**Sacramento Employment and Training Agency (SETA)  
Invitation for Sealed Bid (IFSB)  
General Contractor Site Services for  
Modular Classroom at  
Hopkins Park Head Start Site**

**BID ADDENDUM #1**

**Questions From Non-Mandatory Bid Walk 8/21/2018**

EXH-1

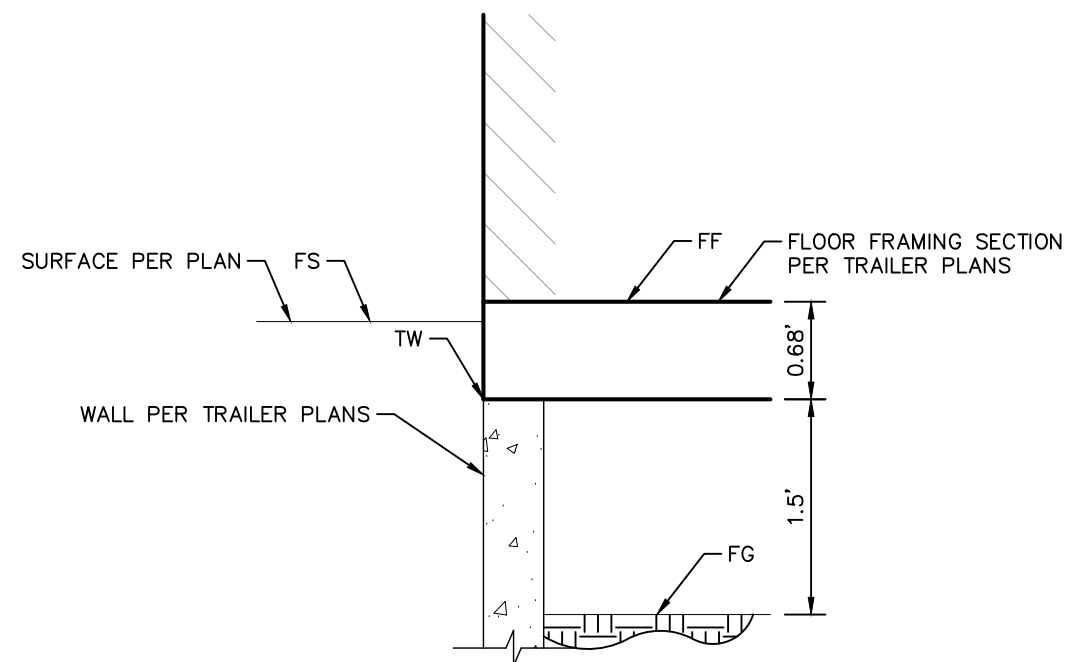
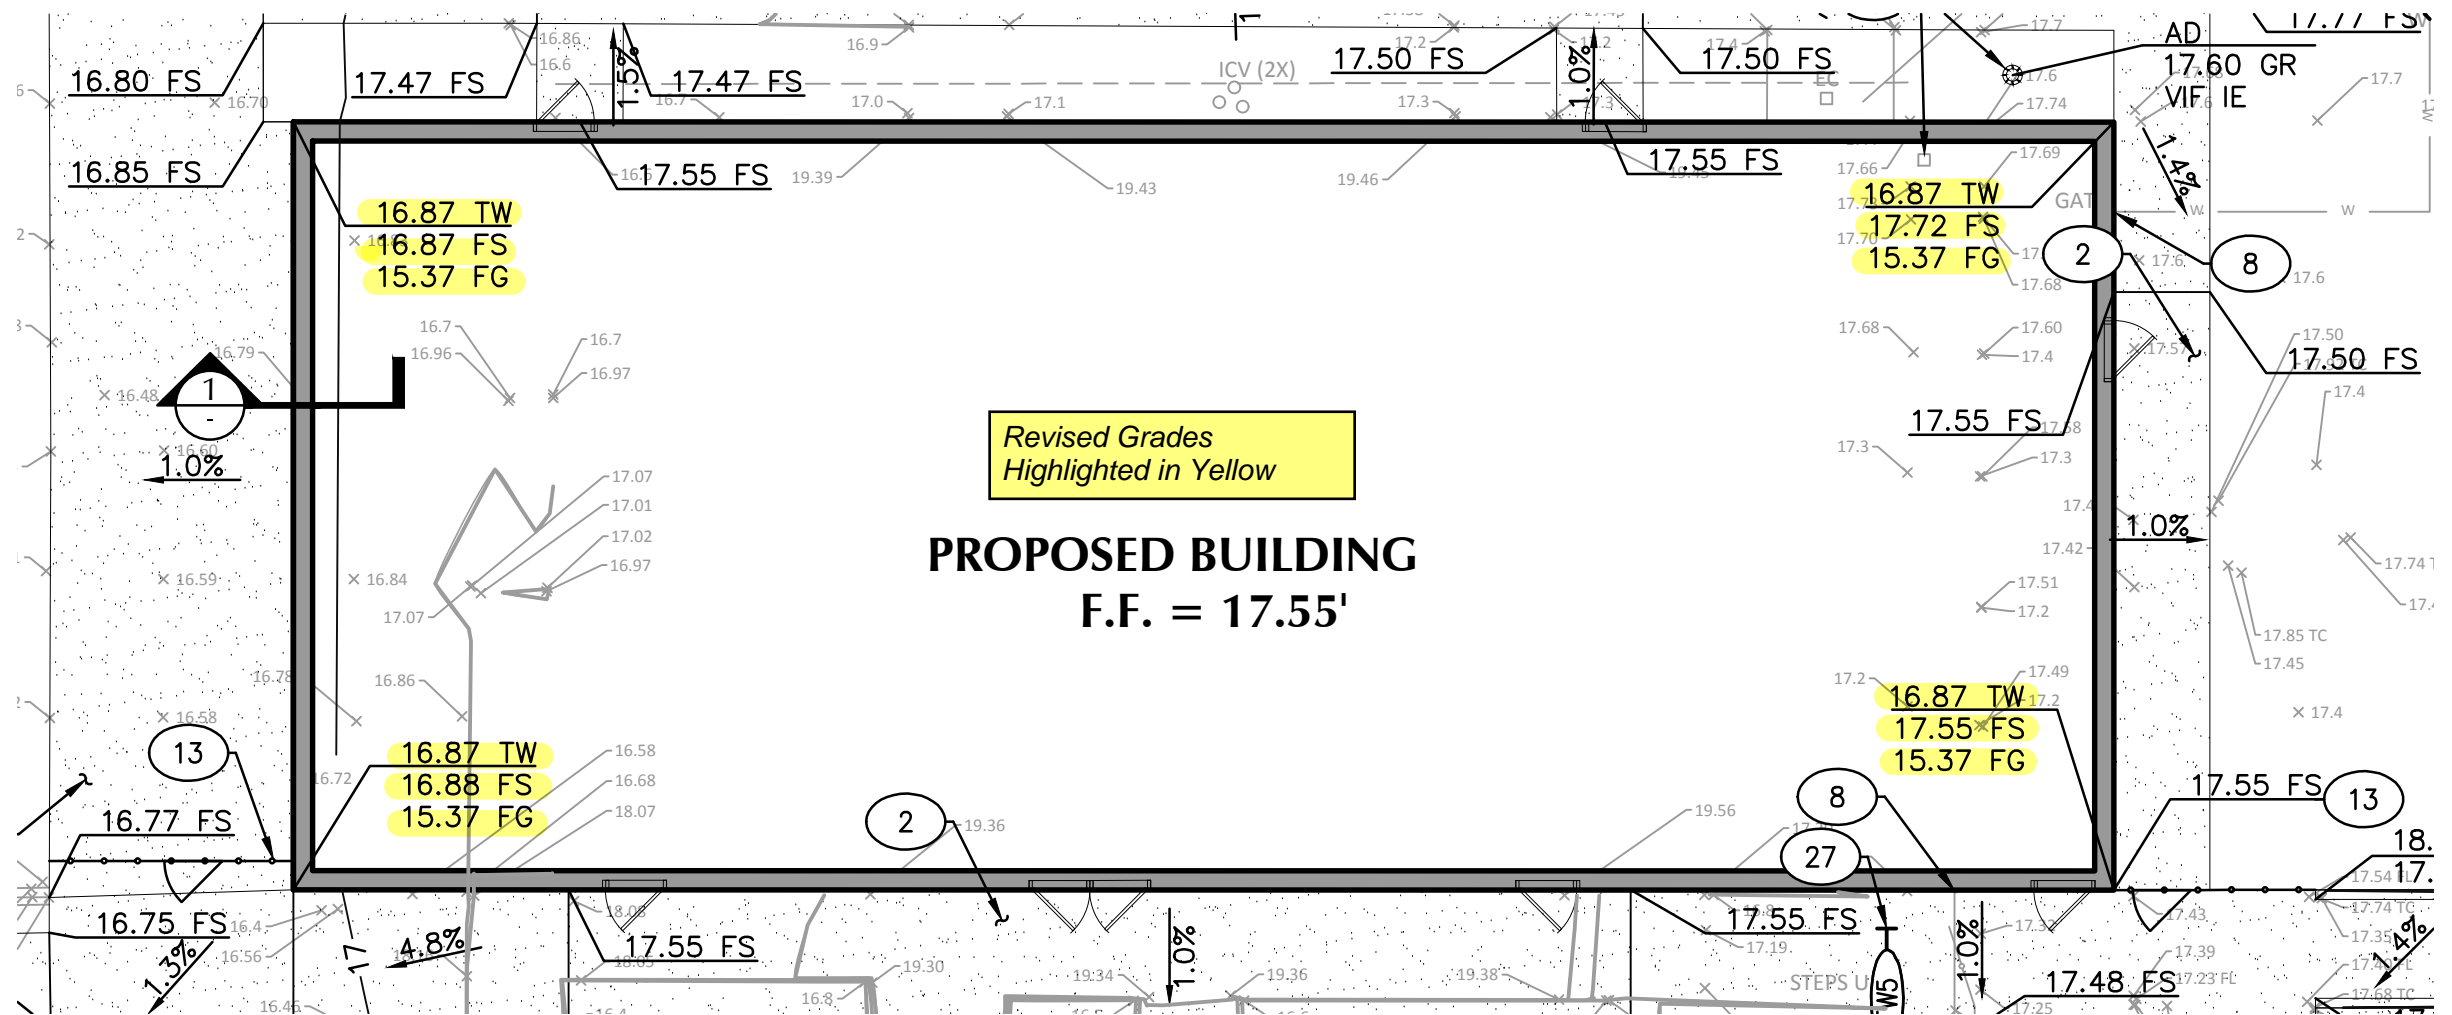
**Q: Grades are not shown for the finished building pad. The responsibility matrix indicates all earthwork is to be by site contractor, except the excavation of the "building/foundation footings", which is by AMS. Please clarify who excavates and compacts the depressed pad required by this design?**

A: Please see attached Civil sheet showing pad grades.

EPM	MR
DRAWN BY	EH
SCALE	AS NOTED
DATE	01/06/2018
PROJECT NUMBER	
1600-17	
SHEET TITLE	
POINT OF CONNECTION DETAILS	
CONCRETE FOUNDATION	
SHEET NUMBER	
POC-2

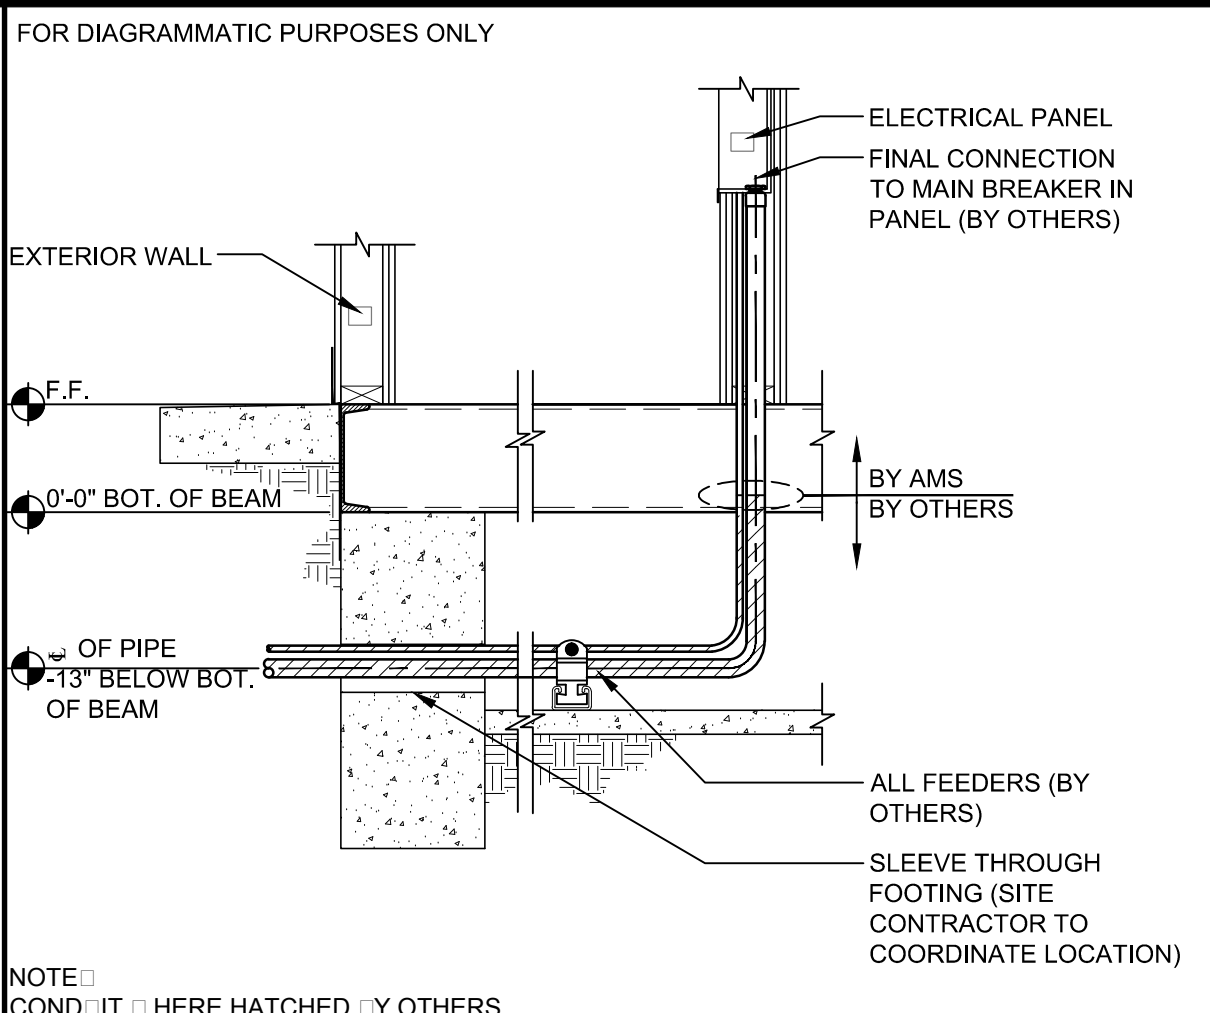
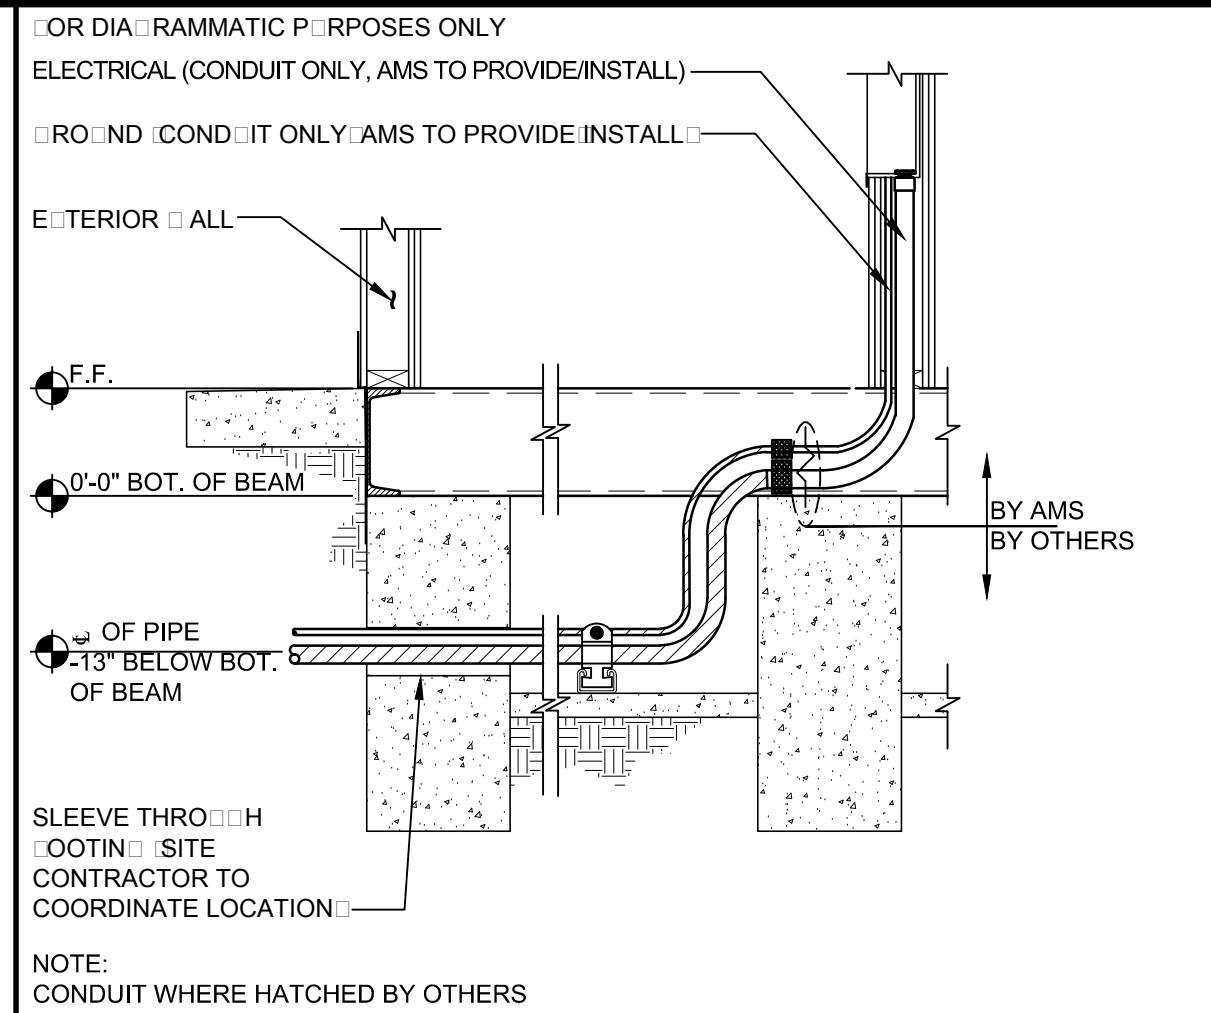
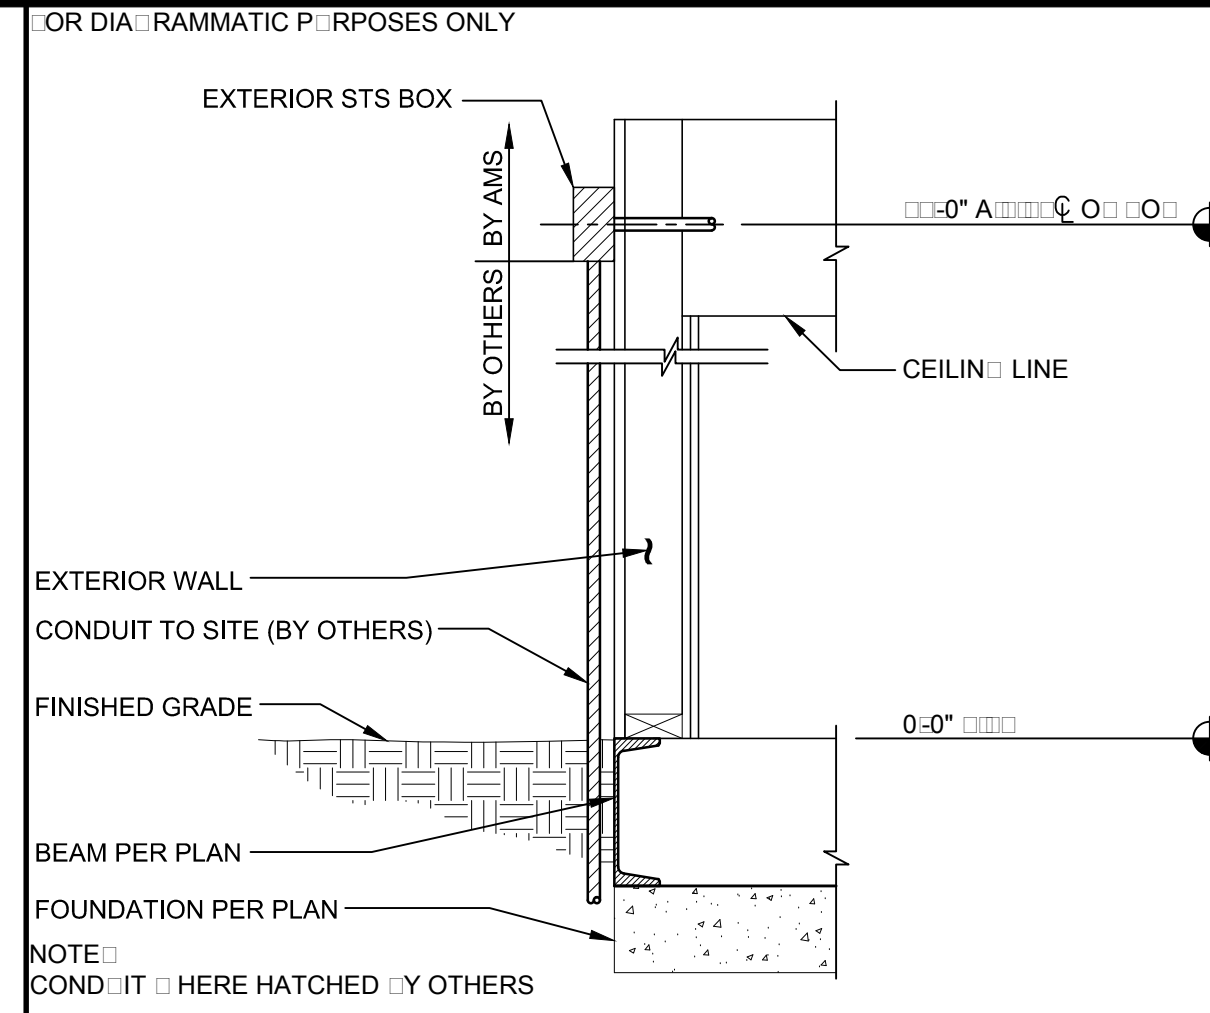
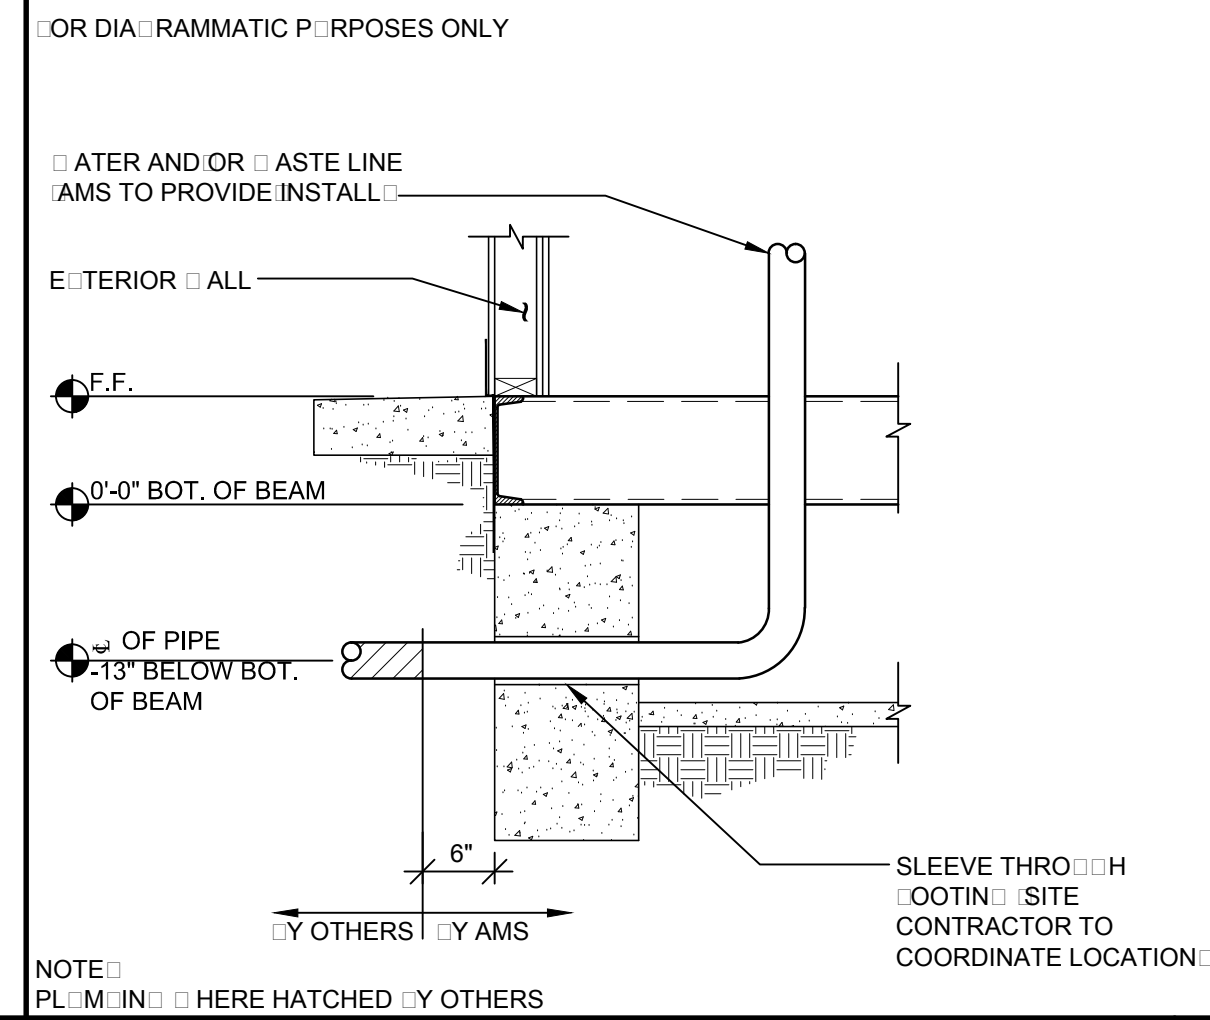
**Q: Page A1.2 and page P1.0 of the AMS plans include a plumbing note which states "all underfloor connections are by site contractor". The responsibility matrix indicates AMS is installing the waste manifold under the building. Please clarify the scope of plumbing connections required to be included in this bid.**

**Q: Responsibility matrix references the “AMC POC plan” for connections to utilities. We cannot locate this POC plan. Please clarify utility points of connection with the AMS building.**

A: See attached AMS POC Sheet.

**A.** Please see attached AMS POC Sheet.
